CALIFORNIA COASTAL COMMISSION

STAFF REPORT: REGULAR CALENDAR

APPLICATION NUMBER: 5-00-393

PROJECT DESCRIPTION: Phase IV of the Harbor Walkway project. Construct approximately one mile of new sidewalk on the seaward side of Paseo del Mar from Western Avenue to Weymouth Avenue and from Roxbury Street to South Gaffey Street in San Pedro. The project includes installation of lookout points with benches, pedestrian and vehicle railings, drought tolerant landscaping, trash receptacles and concrete curb and gutter. Two dirt turnouts will be converted to view sites and a third, paved turnout will be retained.

EXHIBIT # 1
PAGE 2 OF 3

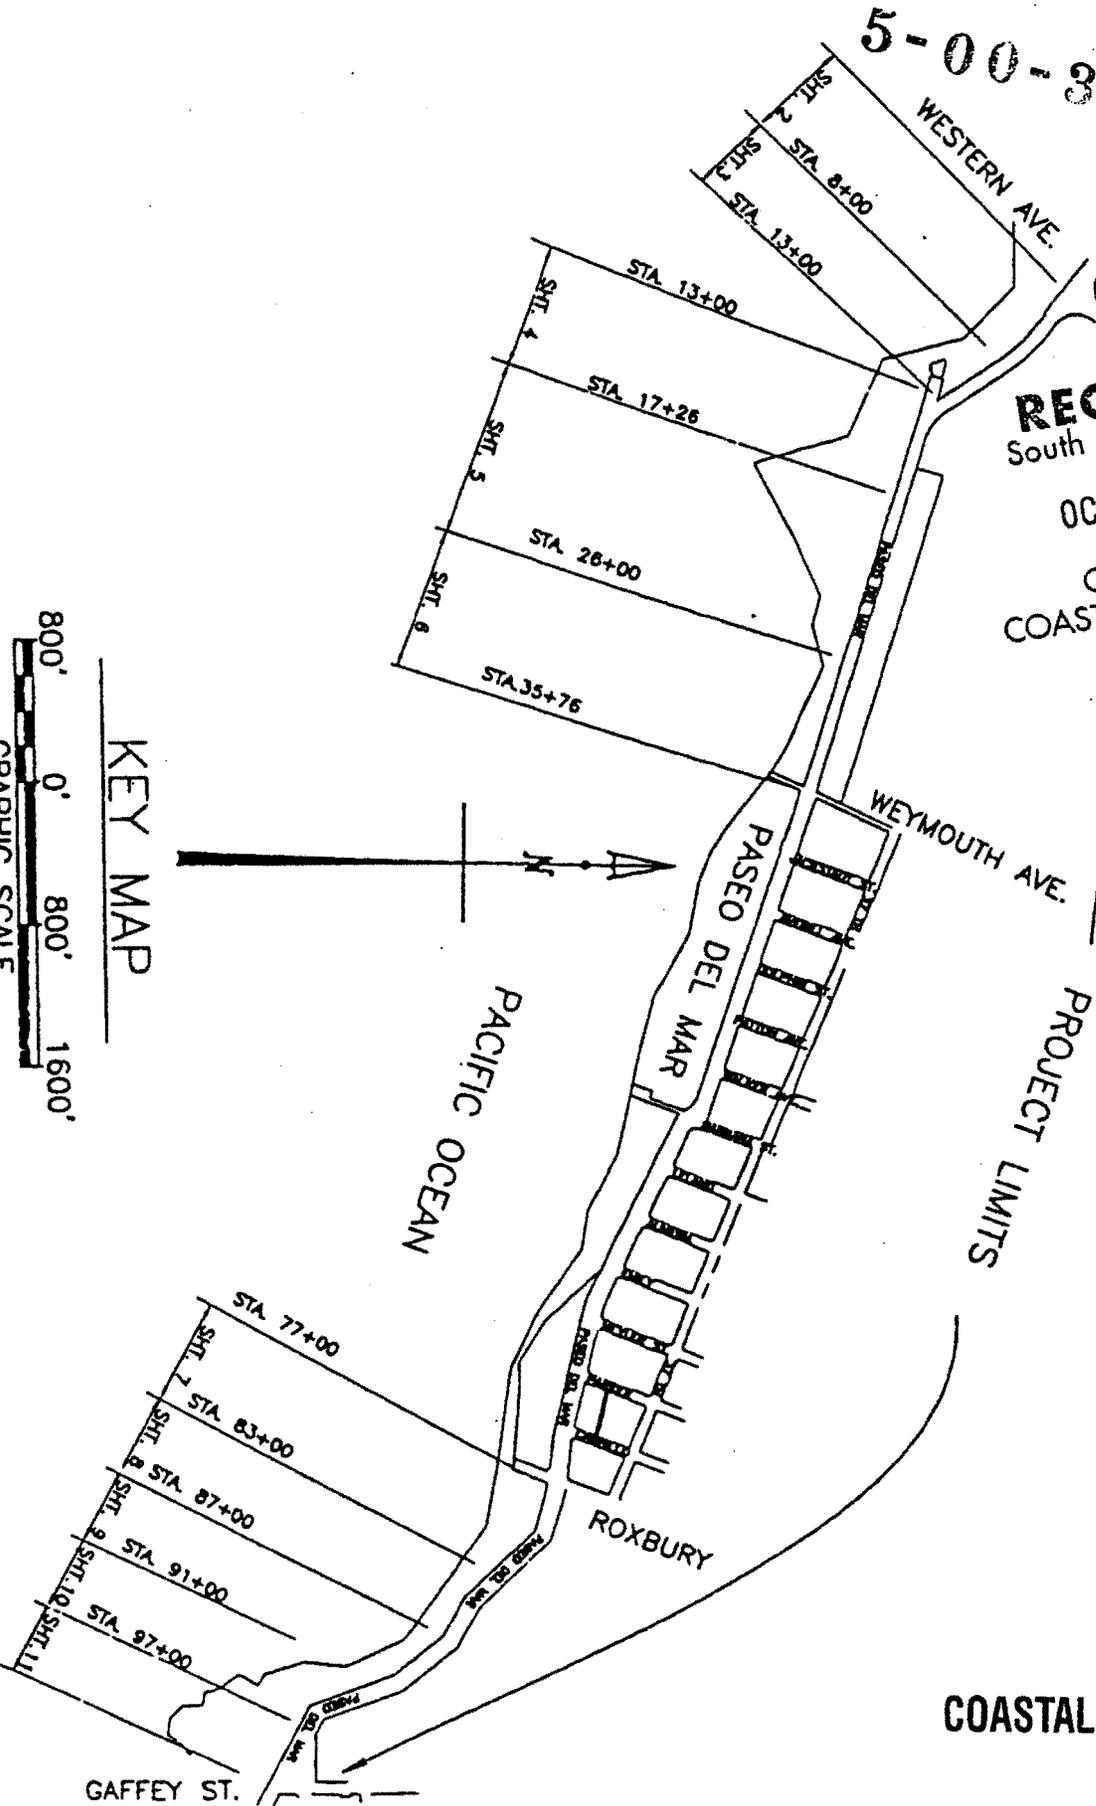
and nonnative drought tolerant landscaping on City and County property along the blufftop at the western segment (See Exhibit #1, p.1) and at one site immediately south of Roxbury Street. Pedestrian and vehicle railings would be installed where necessary for safety. Concrete curb would be placed throughout the length of the project and gutter would be installed where necessary. Existing informal parking would be eliminated at the two dirt turnouts and a third paved turnout would be retained.

The proposed project is partially located within White Point (See Exhibit #1, p.1), a Los Angeles County designated buffer zone (099) in the Significant Ecological Area Report, Los Angeles County Department of Regional Planning and Environmental Systems Research Institute, 1976. According to this 1976 report:

- 1) The plan shall include the following:
 - a) All vegetation planted seaward of Paseo del Mar between Western Avenue and Weymouth Avenue (western segment), with the exception of the Torrey Pine, shall consist of native, drought-tolerant plants of Coastal Sage Scrub and Coastal Bluff Scrub plant communities,

- b) Torrey Pines to be planted at the western segment shall be planted at minimum 40-foot intervals, with the exception of the planting of numerous Torrey Pines clustered on the property seaward of the intersection of Paseo del Mar and Western Avenue,

EXHIBIT # 1

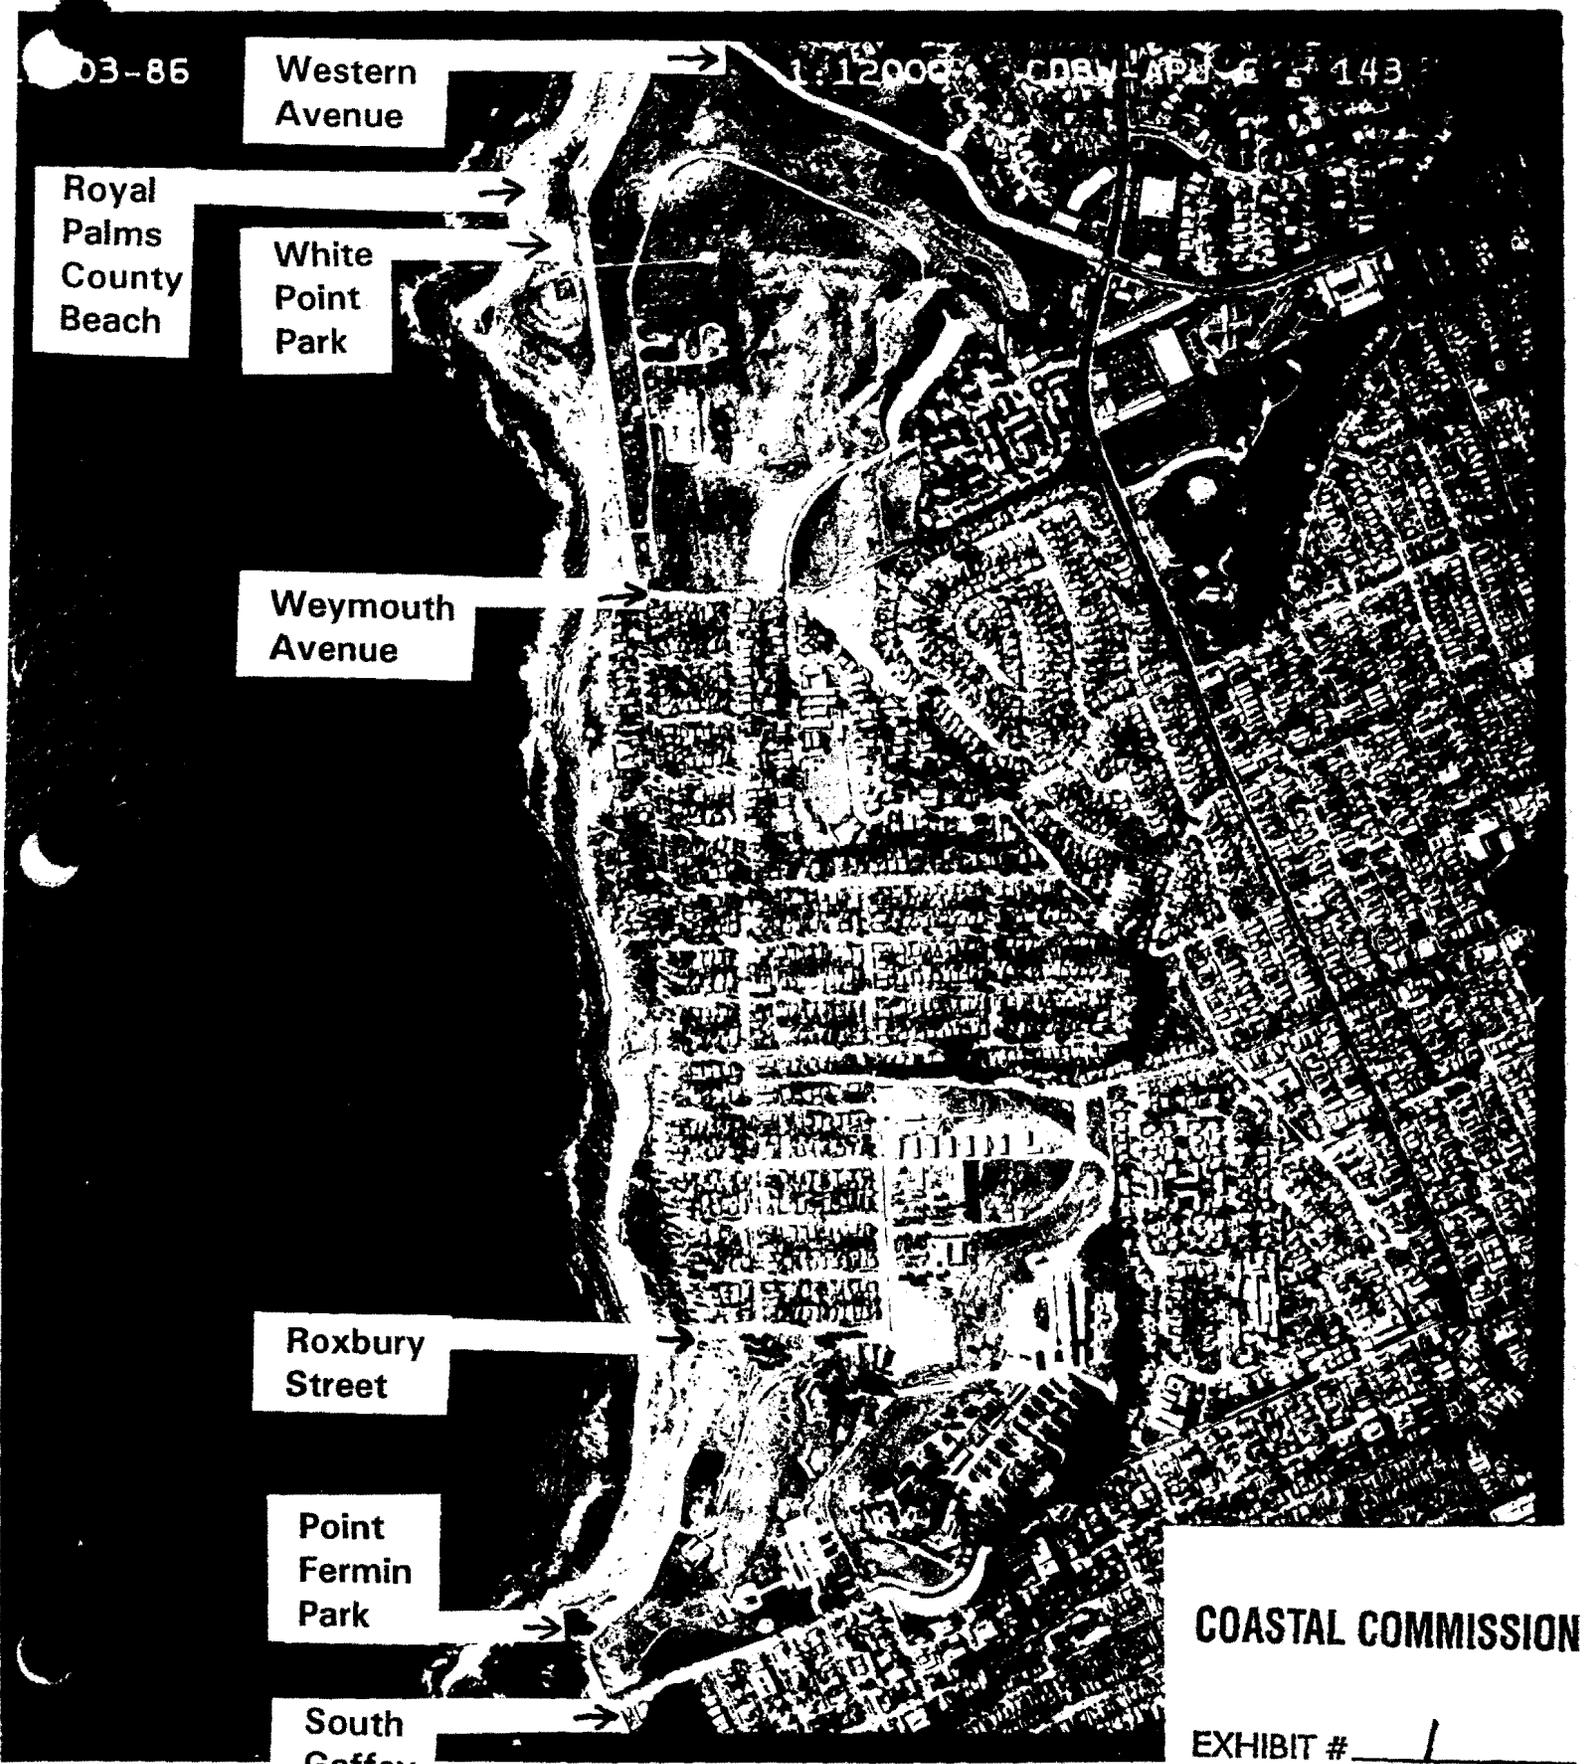
Parking exists in parking lots at White Point Park, Royal Palms County Beach and Point Fermin Park (Exhibit #1, p.3). The Commission notes that support parking is necessary for the walkway development to serve any people other than residents of the immediate area. Currently, designated public parking does not exist on the seaward side of Paseo del Mar south of the baseball field in the western segment. The proposed project, as conditioned, would provide designated curbside parking at the two proposed lookout points. The lookout points are located just west of Weymouth Avenue, approximately 800-1,200 feet and 1,600-2,000 feet east of White Point Park. Curbside parking adjacent to the existing turnout locations would provide direct access to the lookout points and indirect access to the neighboring parks and beach via the proposed walkway.

Part of the proposed project is located within Point Fermin Park and another part is located adjacent to White Point Park, within the City's right of way (Exhibit #1, p.3). The proposed walkway would not directly impact the SEA or the Marine Refuge, conforms to SEA buffer zone recommendations and is consistent with SEA protection and preservation goals. The proposed walkway would provide a transition zone of low-intensity use along the border of the ecological area.
